W3F1-2021-0050

Subject: Response to U. S. Nuclear Regulatory Commission Request for Additional
Information Regarding License Amendment Request to Adopt
10 CFR 50.69

Waterford Steam Electric Station, Unit 3
NRC Docket No. 50-382
Renewed Facility Operating License No. NPF-38

Figure 2-3 - WF3 Seismic Response Spectra

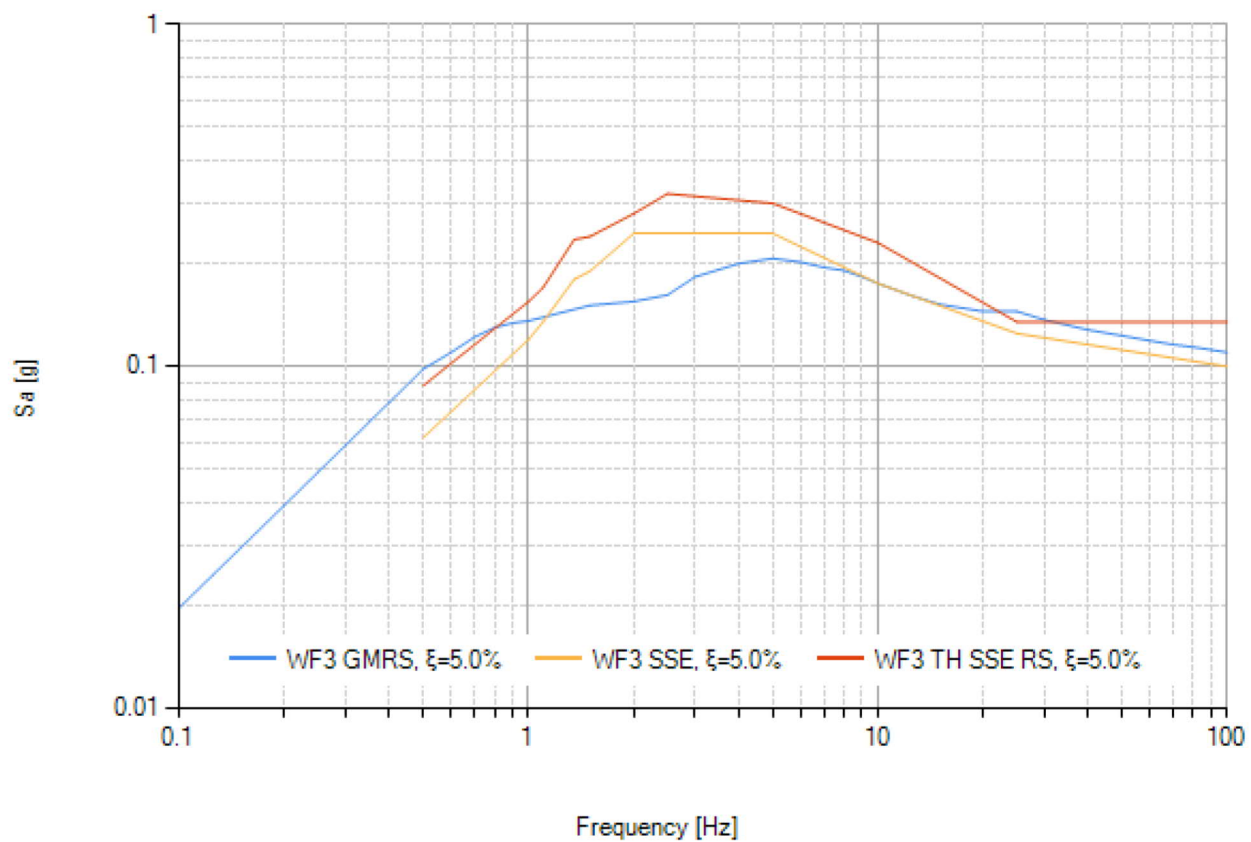
- a. Provide justification for a plant HCLPF capacity of 0.25g used for Waterford 3.
- b. Justify that the plant-specific seismic risk is low relative to the overall plant risk such that the categorization results will not be significantly impacted to support the applicability of the proposed alternative seismic approach to Waterford 3.

The WF3 SSE, SSE TH RS, and GMRS are plotted in Figure 2-3 with associated PGA values of 0.1g, 0.135g, and 0.11g respectively. The 2 - 8 Hz range is generally considered to be the most damaging for SSCs, and it

can be seen that the SSE TH RS exceeds the SSE, which in turn exceeds the GMRS across that frequency range. This implies an intrinsic level of seismic margin built into the design.
